Access Compliance Report

Public Rights-of-Way

(Curb Ramps)

Intersection ID: 6481	Main Street: LOTHAR RIDGE LN	Cross Street: SLATER SPRINGS DR	Location: NW
ADA ID: DAAD98D6844E	Ramp Type: Perp	Initial Pass/Fail: Pass	Overall Compliance: No
Severity Score: 7.75			
Codes/Mitigation Info/Possible Solution		Field Measurements/Component Compliance

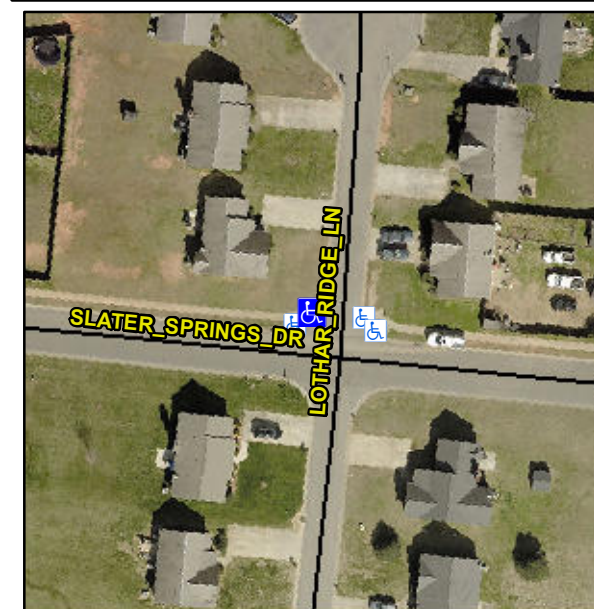
**Not Found, R304.5.3, R305.1.4,
R305.2, R304.5.4**

Compliance	Description	Data	Compliance	Description	Data
N/A	Ramp Length (in)	48.0	Yes	Ramp Slope (%)	5.2
Yes	Ramp Width (in)	54.5	No	Ramp XSlope (%)	2.6
N/A	Flare Type LT	None	N/A	Flare Type RT	N/A
N/A	Flare Slope LT (%)	N/A	N/A	Flare Slope RT (%)	N/A
N/A	Flare Traversable LT?	N/A	N/A	Flare Traversable RT?	N/A
Yes	Landing Length (in)	48.5	Yes	DWS Provided?	Yes
Yes	Landing Width (in)	48.0	Yes	DWS Contrast?	Yes
Yes	Landing Slope (%)	1.3	Yes	DWS Length (in)	24.0
Yes	Landing X Slope (%)	1.0	No	DWS Full Width?	No
N/A	Landing Curb? (Y/N)	No	No	DWS Offset (in)	6.0
N/A	Shared Landing?	No			
Yes	Gutter Ponding?	No	No	Gutter Slope (%)	11.6
Yes	Gutter Lip Ht (in)	0.0	Yes	Gutter X Slope (%)	0.2
N/A	Painted X Walk1?	No	N/A	Painted X Walk2?	N/A
	X Walk 1 Direction	To NE		X Walk 2 Direction	N/A
N/A	X Walk 1 Width (in)	N/A	N/A	X Walk 2 Width (in)	N/A
	X Walk 1 Slope (%)	1.1		X Walk 2 Slope (%)	N/A
	X Walk 1 X Slope (%)	0.5		X Walk 2 X Slope (%)	N/A

**Remove & Replace Entire Ramp.
Remove & Replace Gutter.**
